COMMITTEE ON INTERIOR AND INSULAR AFFAIRS
 U.S. HOUSE OF REPRESENTATIVES
 WASHINGTON, D.C. 20515

As a follow-on to the February 4 briefing, I would appreciate the Commission's answers to the following questions in addition to the information requested by Mr. Markey.

SUBJECT: MEETING WITH WESTINGHOUSE ON STEAM GENERATORS

This is in response to the questions posed in your February 5, 1982 letter relative to the recent event at the R. E. Ginna Nuclear Power Plant. Our responses to your questions are enclosed.

Preliminary Estimate of Leak Rate vs. Time

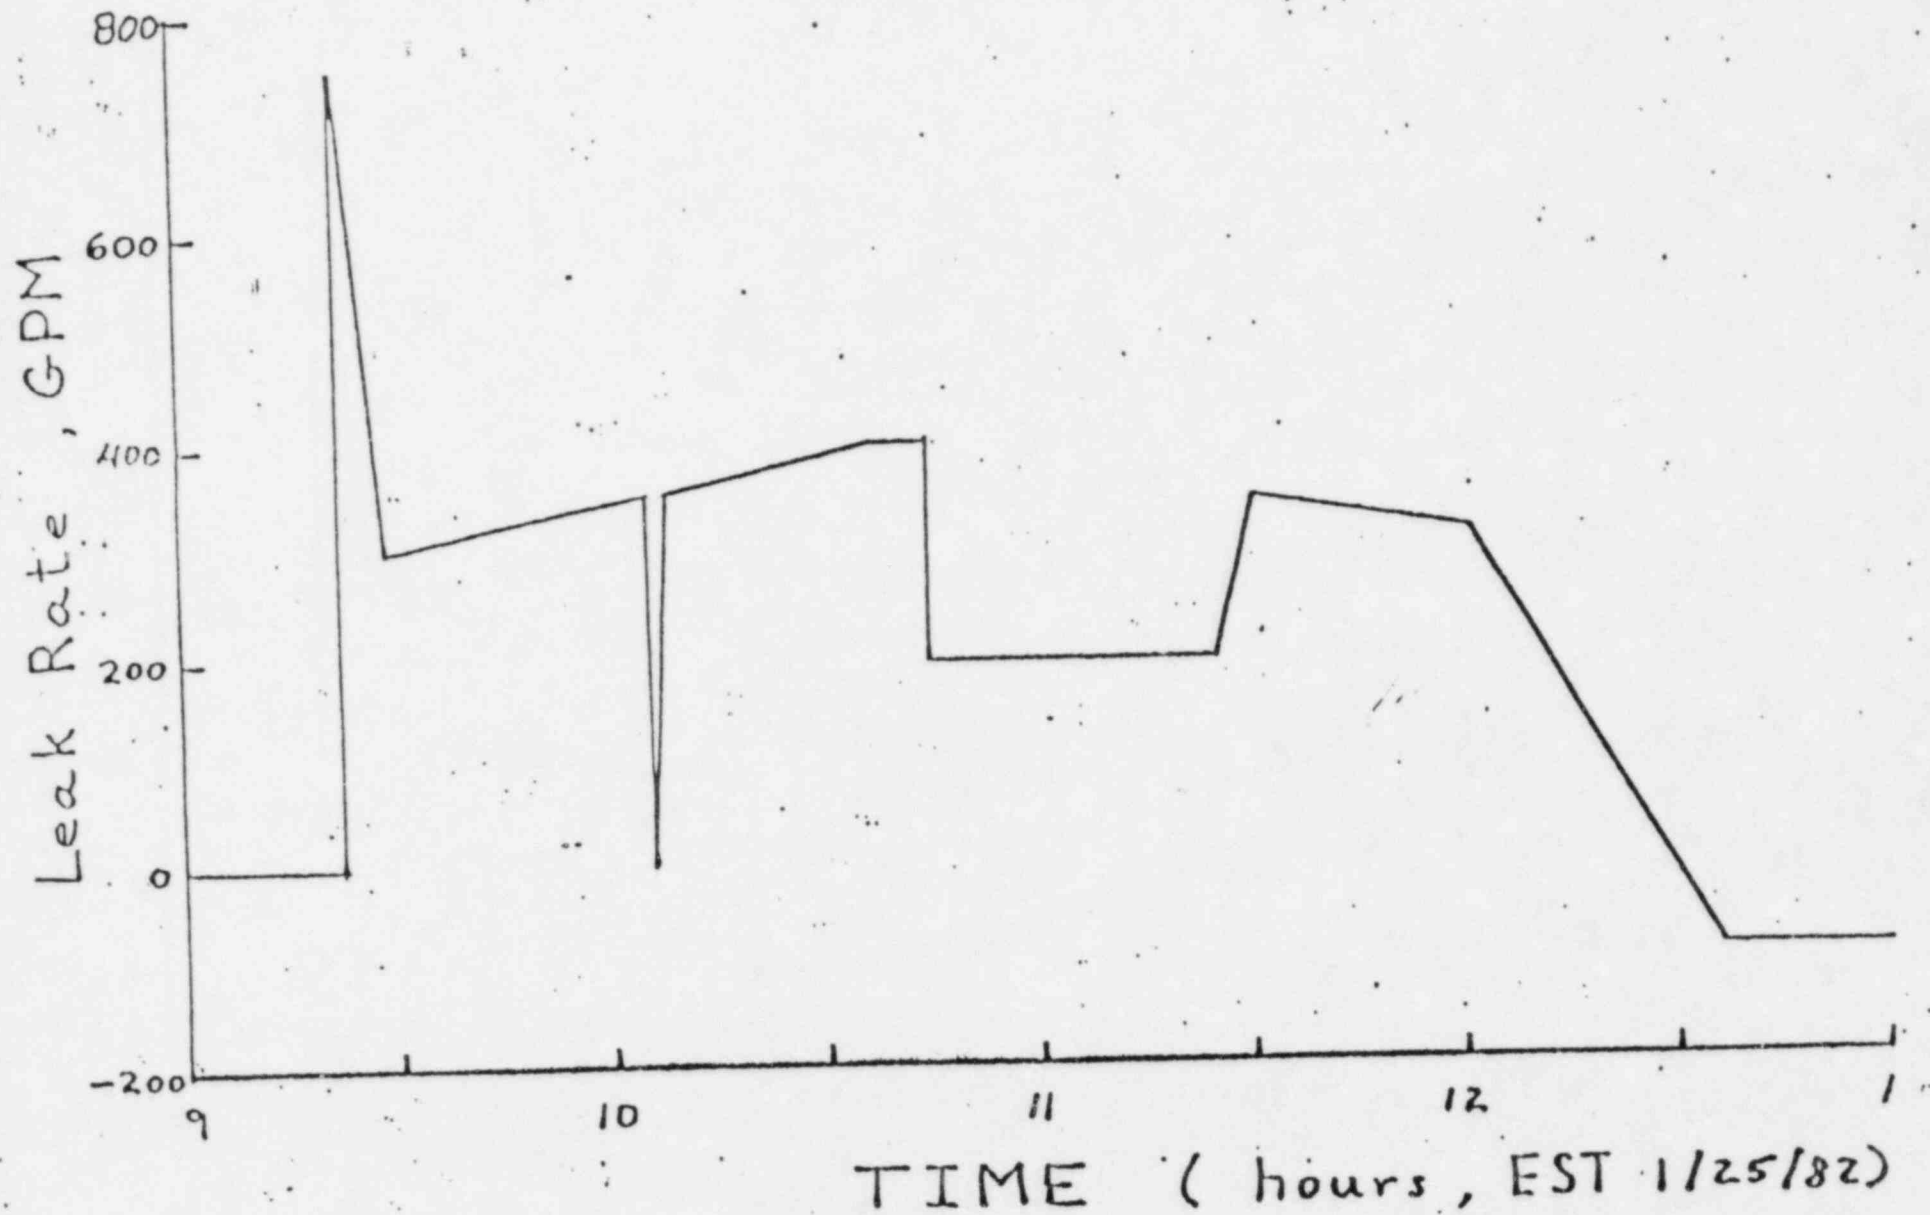
QUESTION 2. What was the leak rate through the break as a function of time?

The attached graph (Figure 1) is our preliminary estimate of the leak rate as a function of time, calculated from information provided by the licensee.
